Product hierarchy no. *				Part no.	SBU	Type / Description	Customer part no.
SBU	PG	PUG	Type				
02	005	016	0000001210	See list below	Power Entry Module	6762 (snap-in)

Change of approval markings from UR and CSA to the combined cURus on the product socket.

Product Change Notification					PCN 6762 (snap-in)		
owner	creation date	release date	released by	change order no	rev	page	D10-039-976
huberth	25.09.2019	01.10.2019	limachcl	2018434	A	1 of 1

3 Detailed description of change

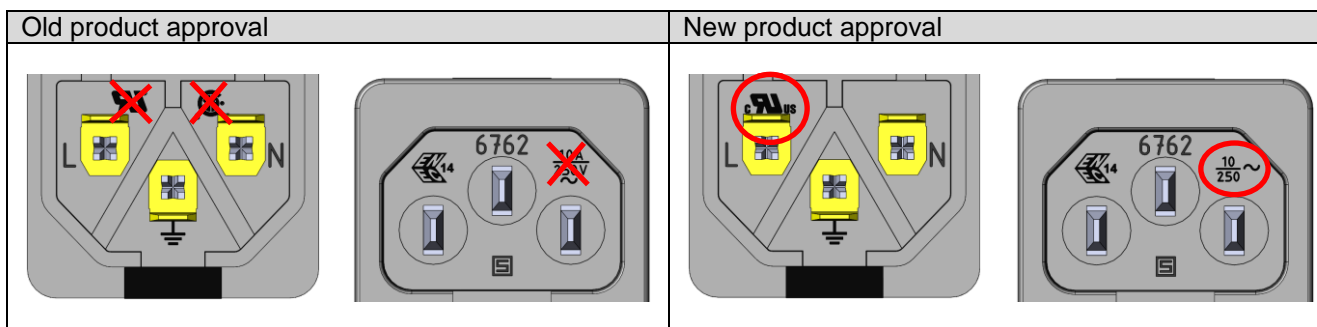
Form	Yes	Socket new with cURus approval marking
Fit	No	-
Function	No	-
Manufacturing	No	-
Label	No	-
Packaging	No	-
